Florida Department of
Environmental Protection
Inspection Checklist

Facility Name: PASCO COUNTY RESOURCE RECOVERY

On-Site Inspection Start Date: 12/14/2010

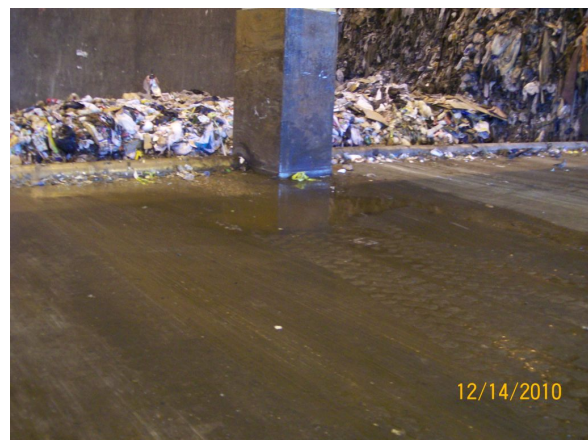
Item 12.7 - Damage (cracks, gouges, etc) to the concrete pad was observed in the containment area outside of the grizzly bunker which needs repair. Please provide documentation that these areas have been repaired and that the pad is sufficiently sloped to allow for drainage to the grizzly sump.

Minor ponding/damage was also observed on the tipping floor. This area should be watched and repaired as necessary.
